Project	IEEE 802.16 Broadband Wireless Access Working Group < <a href="http://ieee802.org/16">http://ieee802.org/16</a> >	
Title	Fixes for Network Entry Flow Charts	
Date Submitted	2007-03-13	
Source(s)	Nadav Lavi et al Alvarion Ltd. [Address Line 1] [Address Line 2]	Voice: +97236457834 Fax: [Fax Number] <a href="mailto:Nadav.lavi@alvarion.com">[mailto:Nadav.lavi@alvarion.com]</a>
Re:	IEEE Std 802.16-2004/Cor2/D2	
Abstract	Fixes for Network Entry Flow Charts in 802.16-2004/Cor2/D1	
Purpose	For the review in 802.16 Maint TG	
Notice	This document has been prepared to assist IEEE 802.16. It is offered as a basis for discussion and is not binding on the contributing individual(s) or organization(s). The material in this document is subject to change in form and content after further study. The contributor(s) reserve(s) the right to add, amend or withdraw material contained herein.	
Release	The contributor grants a free, irrevocable license to the IEEE to incorporate material contained in this contribution, and any modifications thereof, in the creation of an IEEE Standards publication; to copyright in the IEEE's name any IEEE Standards publication even though it may include portions of

Figure 70d – Network entry state-machine SS side

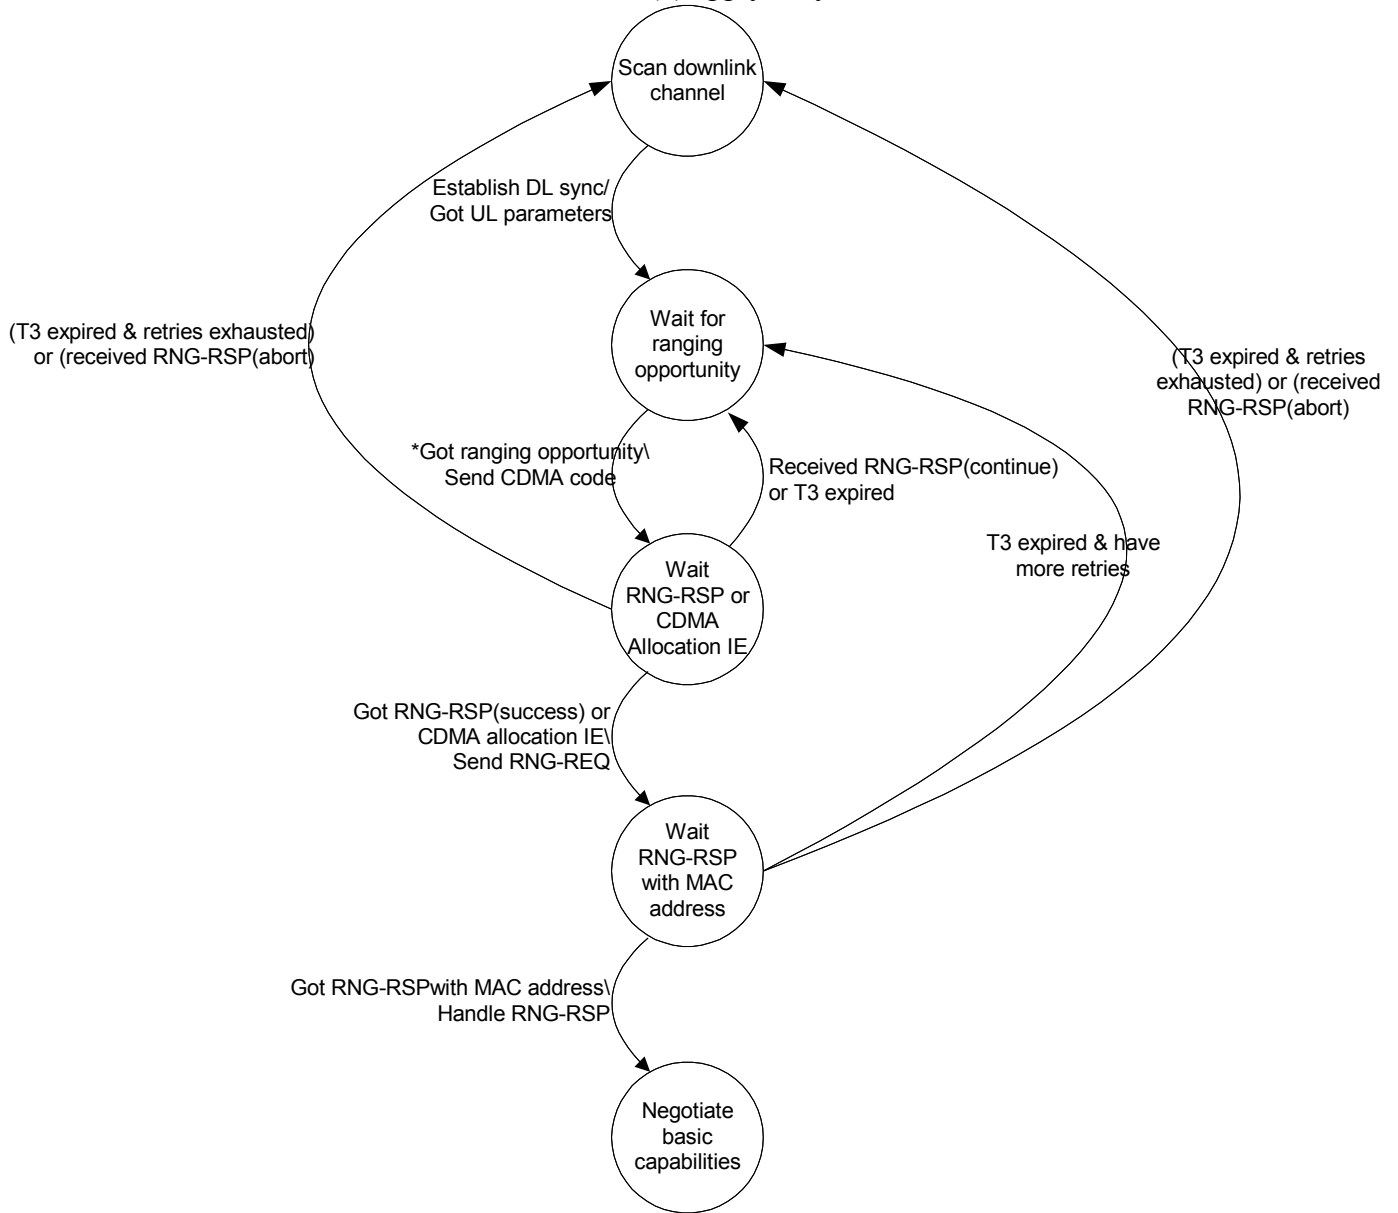
In 802.16-2004/Cor2/D2, add the following text at the end of Section 6.3.9.9, and change Figure 70b with the following Figures 70d:

The following Figure describes the Ranging procedure within the NW entry process on MS side. The transitions and states that are marked with asterisks (\*) apply only to OFDMA PHY.

Figure 70e – Network entry state-machine SS side

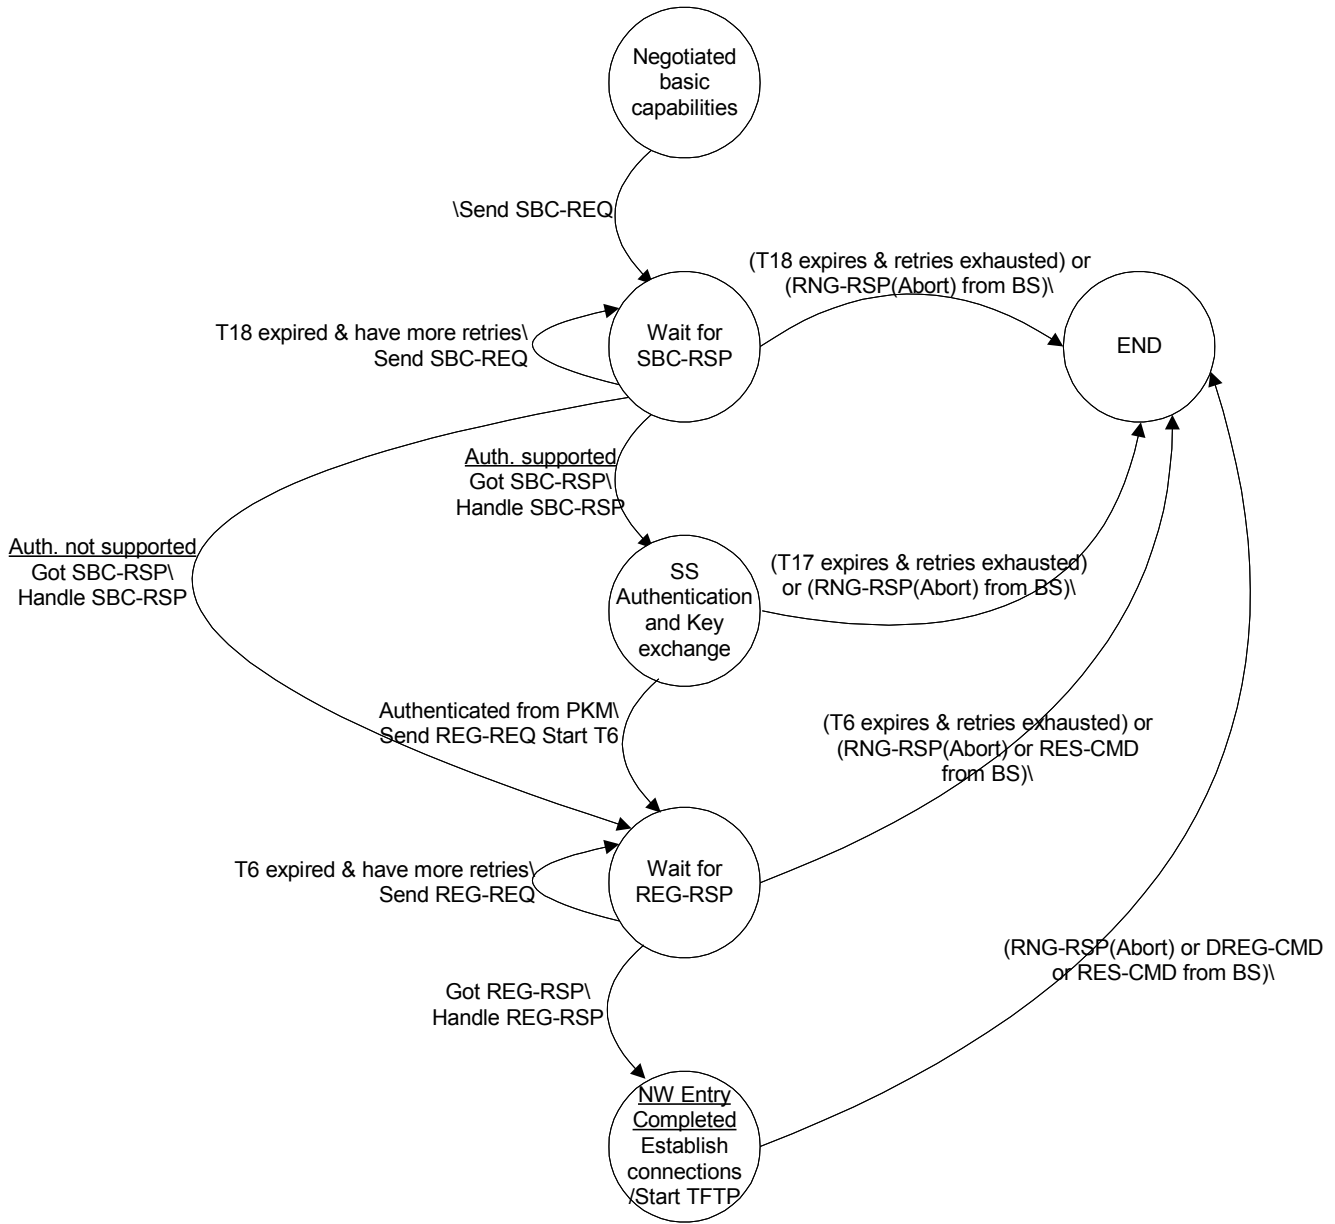
*In 802.16-2004/Cor2/D2, add the following text at the end of Section 6.3.9.9, and add the following Figure 70e:*

The following Figure describes the Ranging procedure within the NW entry process on MS side. The transitions and states that are marked with asterisks (\*) apply only to OFDMA PHY.
